# 9TH STREET PARTNERS - 223RD ST. SITE

PROJECT  
2nd PLANNING SUBMITTAL

HERDMAN A+D  
RESPONSE  
MARKUP  
11.15.2021

EXHIBIT NO. 2

1 PROPOSED SITE PLAN 1" = 40'-0"

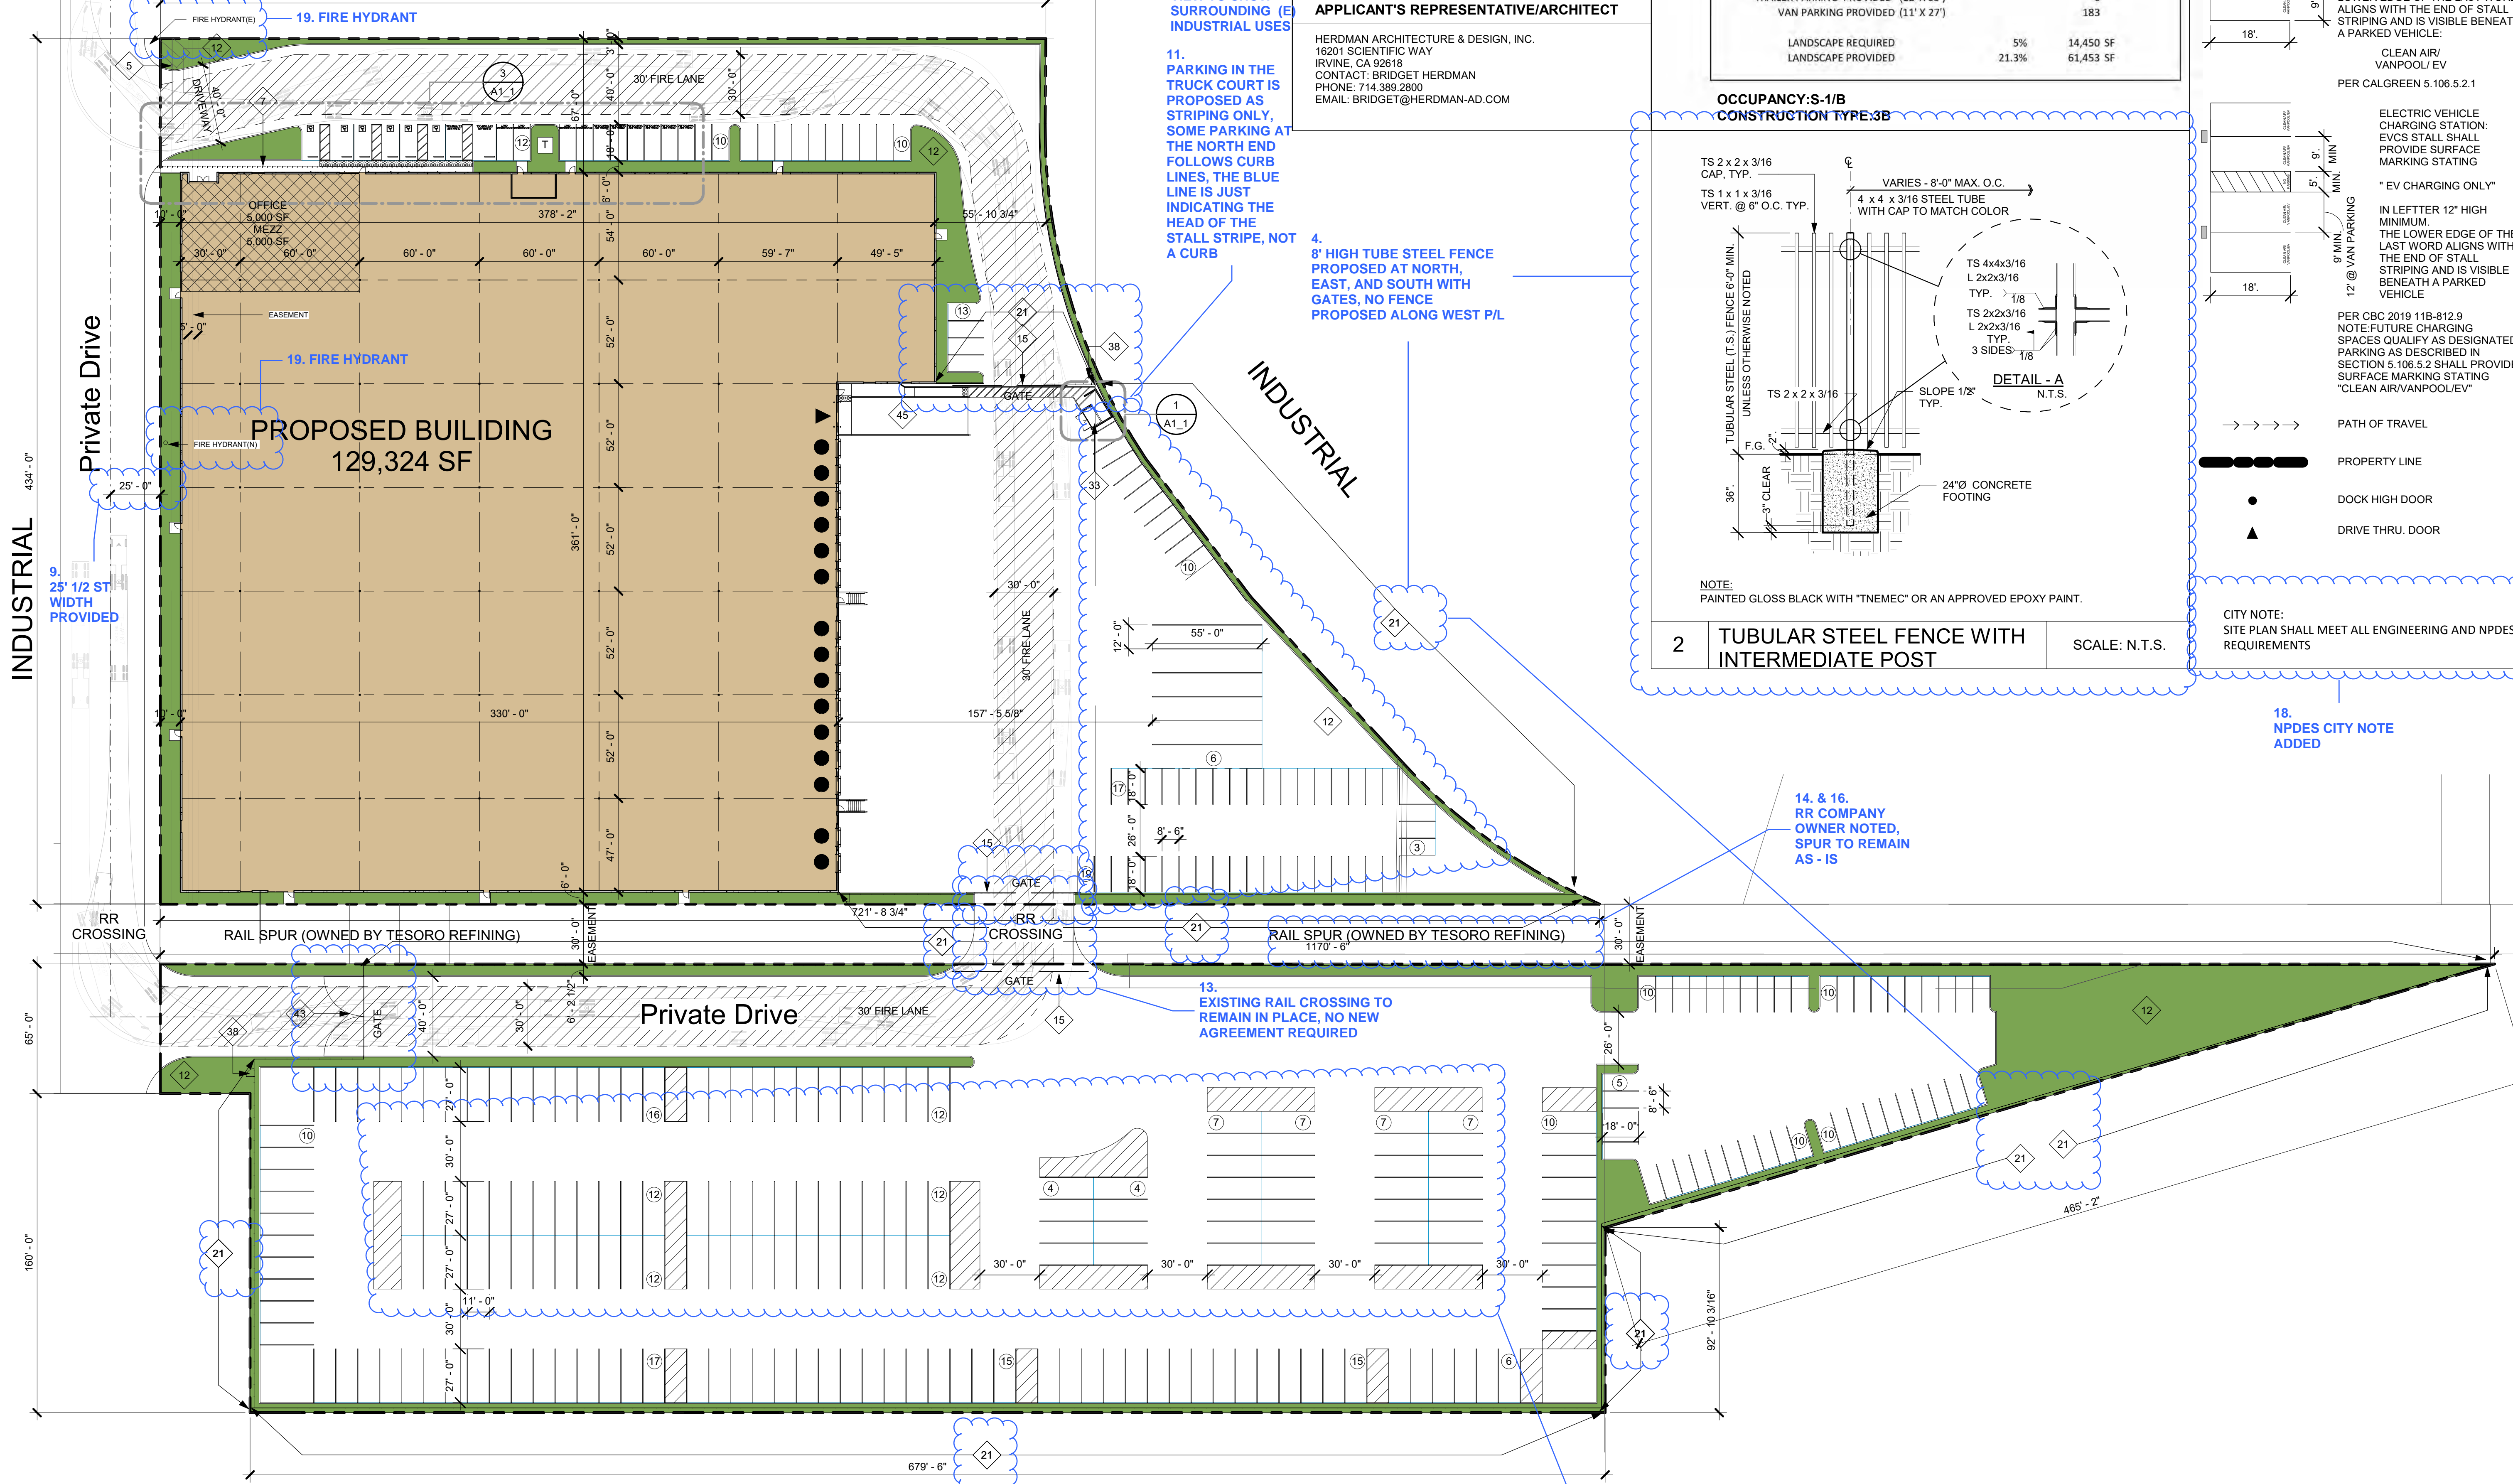
17. GOOGLE EARTH VIEW TO SHOW SURROUNDING INDUSTRIAL USES

11. PARKING IN THE TRUCK COURT IS PROPOSED AS STRIPING ONLY. SOME PARKING AT THE NORTH END FOLLOWS CURB LINES, THE BLUE LINE IS JUST INDICATING THE HEAD OF THE STALL STRIPE, NOT A CURB

4. 8' HIGH TUBE STEEL FENCE PROPOSED AT SOUTH, EAST, AND SOUTH WITH GATES, NO FENCE PROPOSED ALONG WEST PL

18. NPDES CITY NOTE ADDED

14. & 16. RR COMPANY OWNER NOTED, SPUR TO REMAIN AS-IS

13. EXISTING RAIL CROSSING TO REMAIN IN PLACE, NO NEW AGREEMENT REQUIRED

12 & 15. LANDSCAPE DIAMONDS CANNOT BE PROVIDED IN THE SOUTHERN PARKING LOT TYP. AS THIS AREA MAY HAVE STRIPING ADJUST FOR FUTURE TENANT SPECIFIC NEEDS
